SEWAGE DISPOSAL SYSTEM

SUBDIVISION Hickory Hill Farms LOT 4 ROAD 12525 Marlow Road

PROPERTY OWNER Jon and Vanessa Fuller

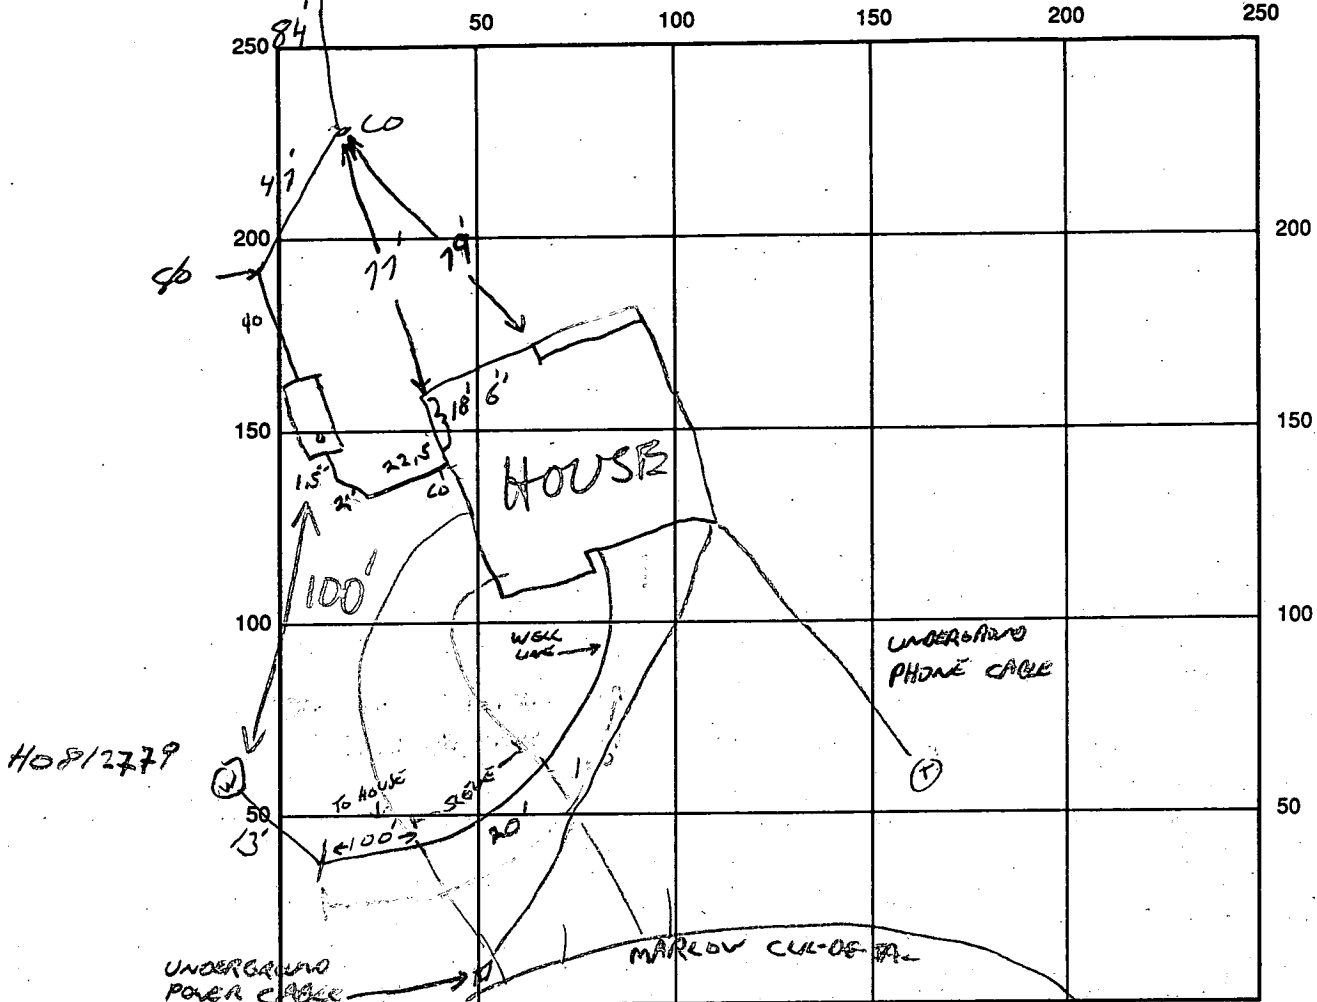
REMARKS: 10/26/95 WRT OK FOR 40 ON 10/27/95 CONTRACTOR WANTS
TO COVER TO DIST BOX. 10/27/95 CLEANOUT TO BE ADDED AT 1ST 45°
ELBOW AFTER TANK. OK TO COVER HOUSE TO DIST BOX.
10/30/95 CLEANOUT ADDED. CONTRACTOR REPORTS UP TO 2' ELEVATION
VARIATION. WRAP TRENCHES AROUND CORNER TO MINIMIZE EXCESS ELEVATION + LOSS OF AREA
MAINTAIN 10 BETWEEN TRENCHES, OR TO INCREASE BOTTOM DEPTH TO 8.5' IF REQ.

11/3/95 OK to cover
if air is inspected on line
pathways and no drawing
clear

INSTALLATION DIAGRAM, PAGE 2 OF 2, &

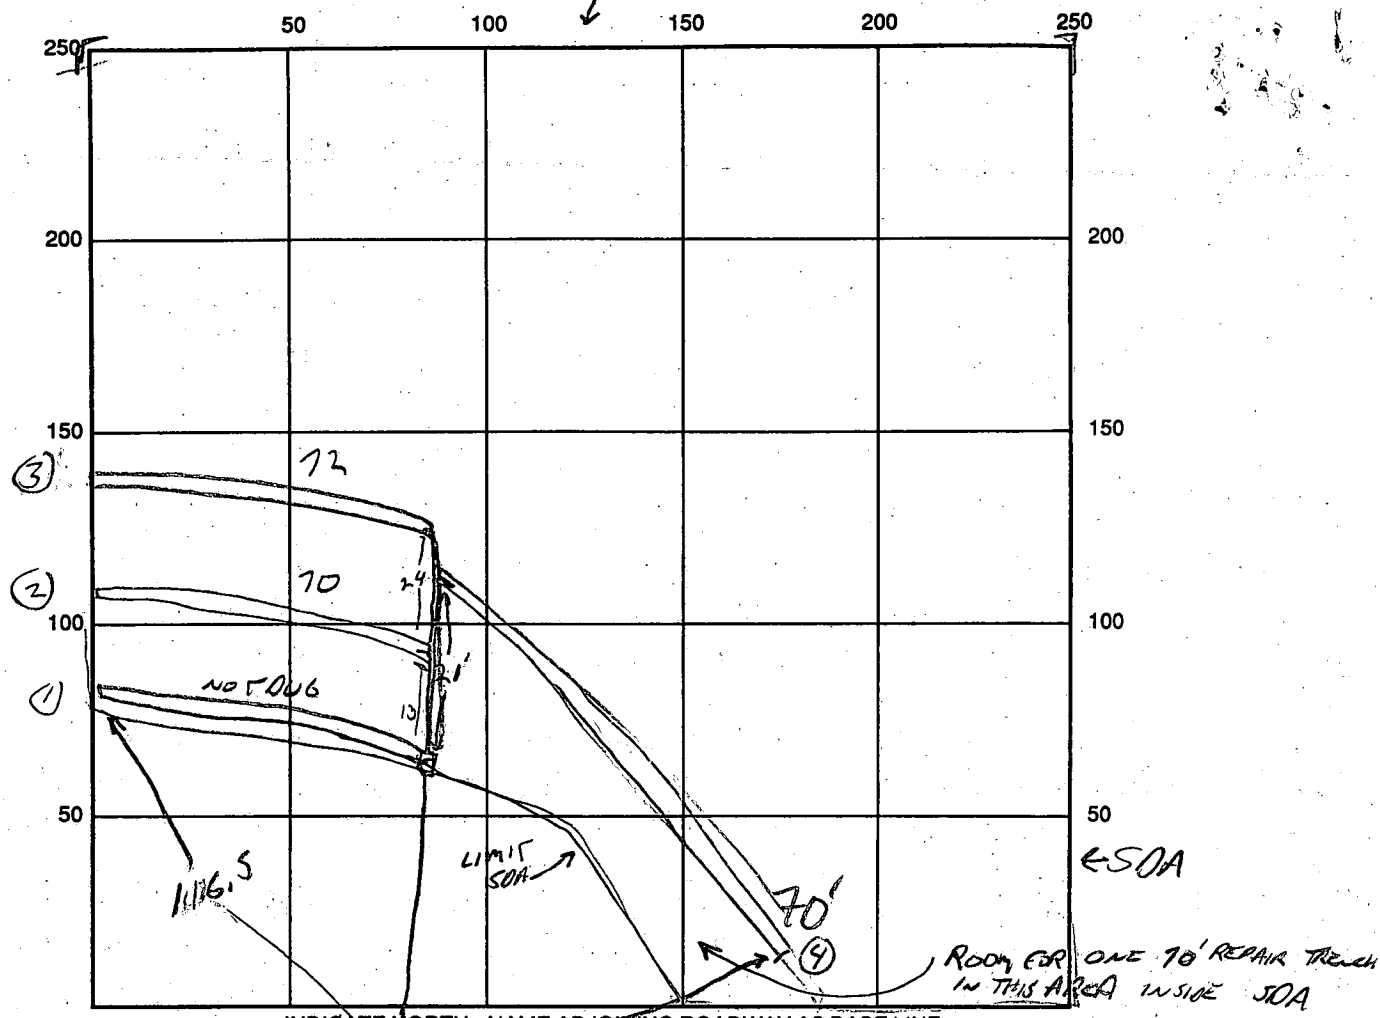
REMARKS: ^{2/2/75} TRENCH 4 HAS 5" EXTRA AREA FOR LENGTH OF TRENCH OF TO
COVER TRENCH 2, 3 AND INLET END OF TRENCH 4. LEAVE FAR END
TRENCH 4 OPEN, END OF TRENCH ONE OPEN. J

SITE PLAN
 SCALE: 1" = 50'

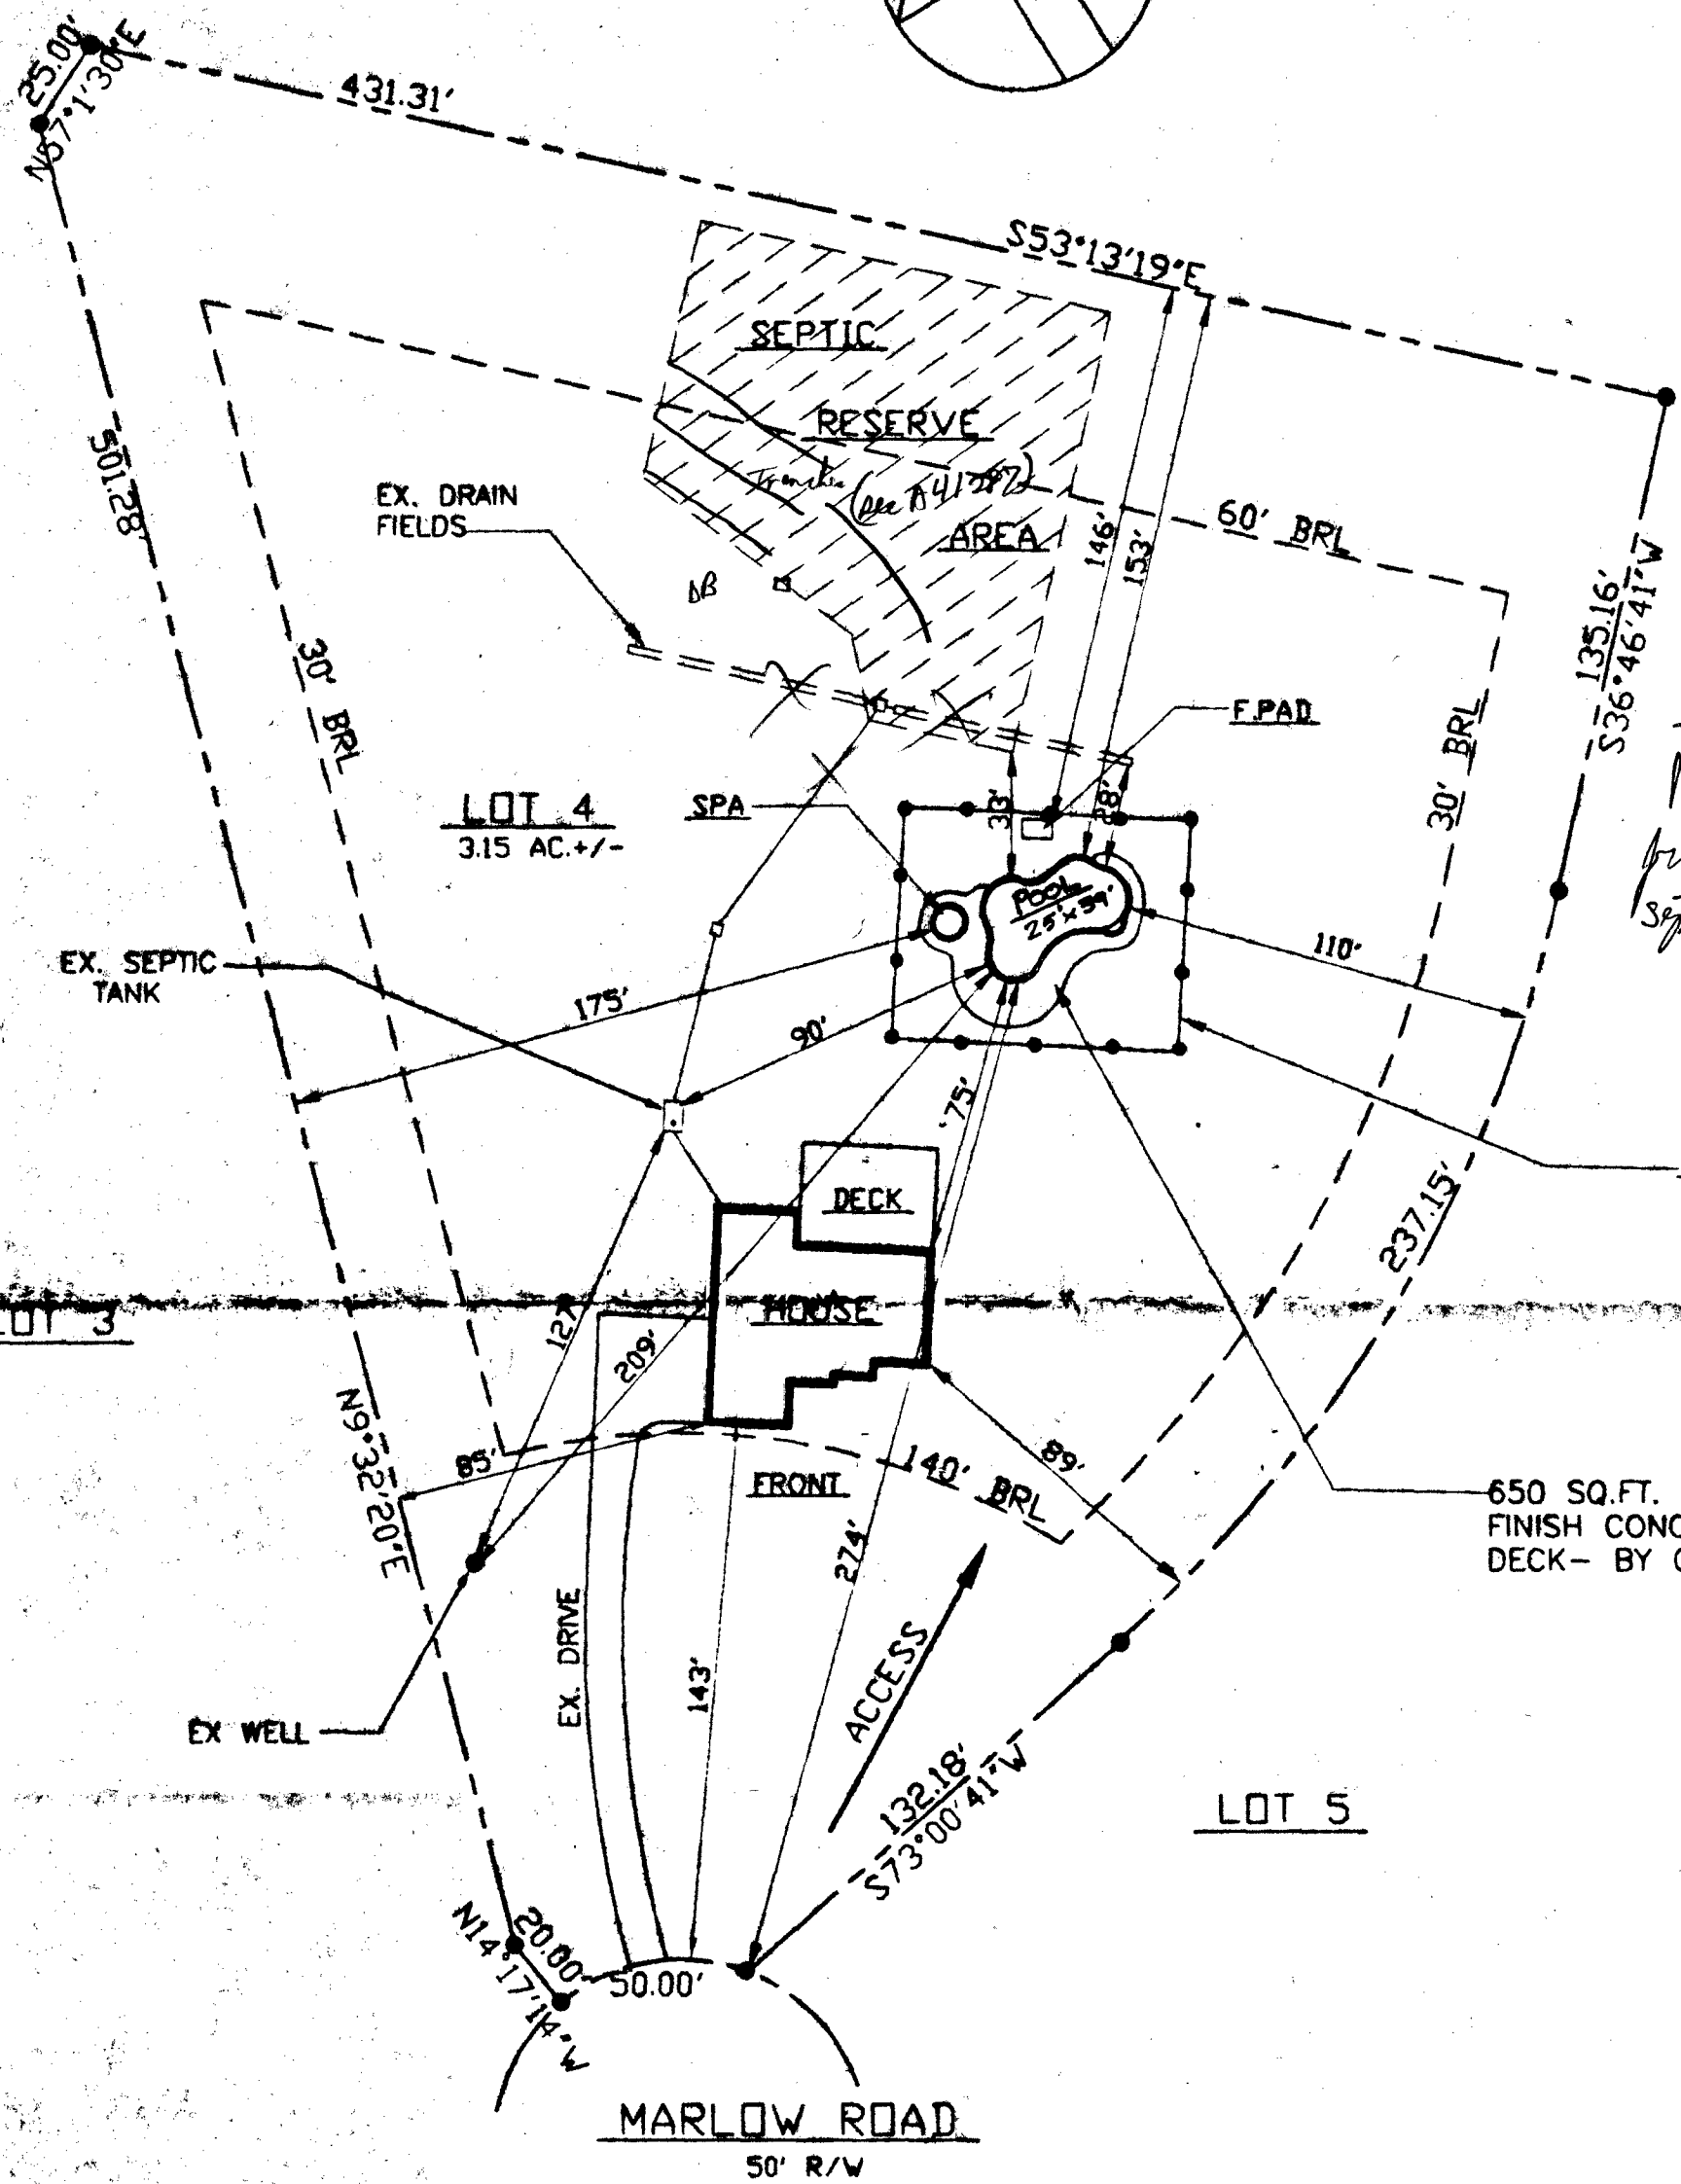
B06116903
*No problem with pool spacing
 from all parts of Septic System
 Septic Area
 OK to issue P.P.
 App'd by 3/25/99*
